ANNEX F  
REPORTS PROVIDED BY RECOVER  
TO SUPPORT THE  
PROJECT IMPLEMENTATION REPORT

## F.1 C-111 SPREADER CANAL PROJECT DRAFT SYSTEM-WIDE EVALUATION REPORT UPDATE (FEBRUARY 27, 2007)

Project Managers and Planning Technical Leads  
C-111 Spreader Canal Project  
Comprehensive Everglades Restoration Plan

Figures 1A-1F: Alternative Salinity in Taylor Slough, Little Madeira, and Taylor River during dry years (Figures A-C are based on old model runs and D-F are based on the current alternative runs).

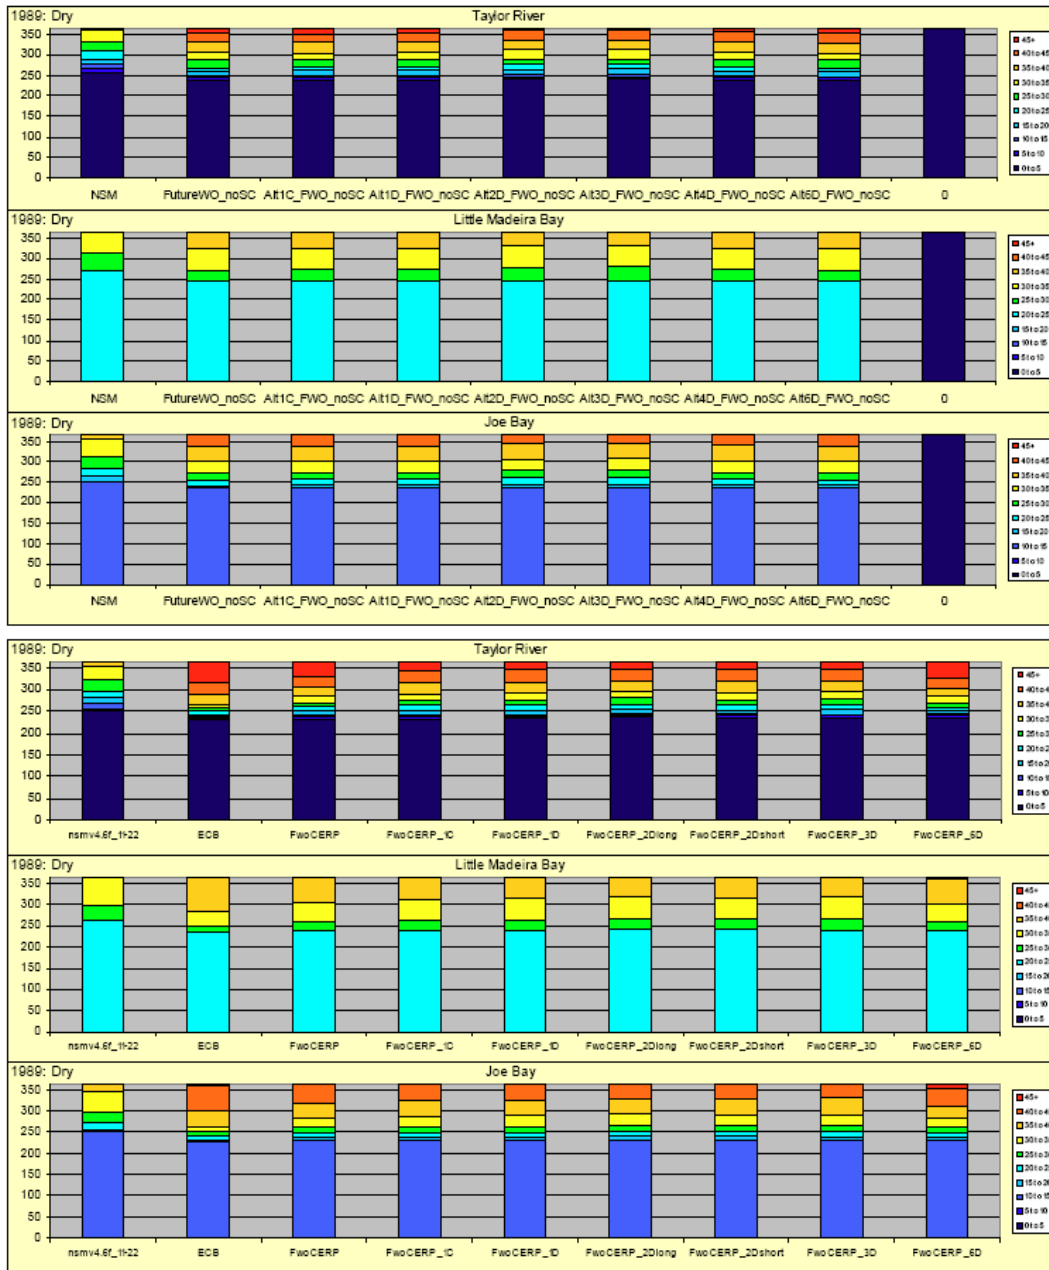
- i. Salinity PM- As noted by the project evaluation of benefits (Table 1), alternatives 2DL, 2DS and 6D perform the best. Although formulation without (FWO) and Existing CERP Baseline (ECB) perform well overall, they do not provide additional benefit to TS which is the focus of phase 1 of the C-111SC project. The actual magnitude of change in salinity is noted in figures 1D-1F for a subset of the basins under the dry year condition (1989). Taylor Slough and Little Madeira show a reduction in the total number of days experiencing the highest (undesirable) salinity classes.

Figure 9- SFWMM flows through the S-177

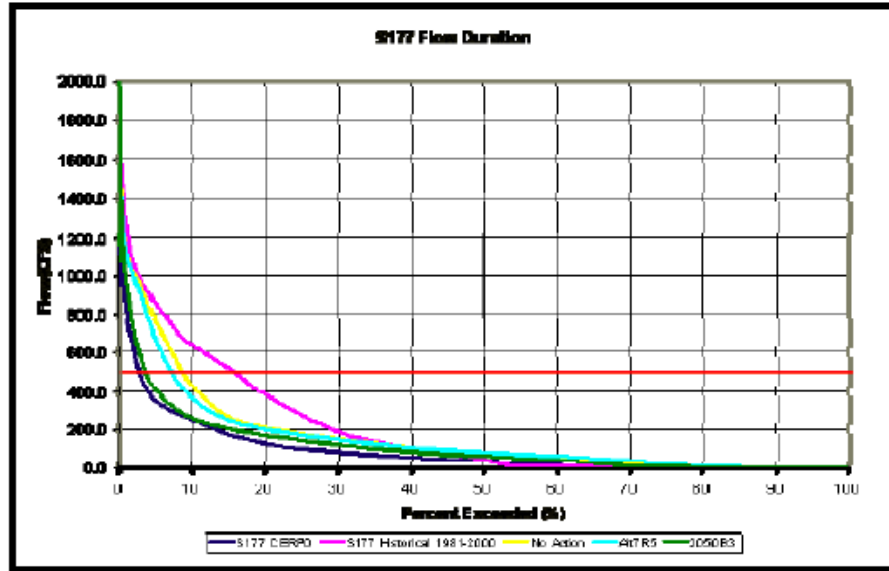
Although the S-177 flows under Cerp0 and 2050B3 condition are nearly the same, many of the components of the future without project condition have not yet been implemented (as detailed in the February 2009 report). It is likely more appropriate to compare to existing conditions to determine the differences between with project conditions with CERP and the no action alternative. This will provide a more realistic comparison based on current projects and operations. This has implications on the Greater Everglades boundary model conditions as can be seen by the magnitude of change in flow at the S-177 (Figure 9).
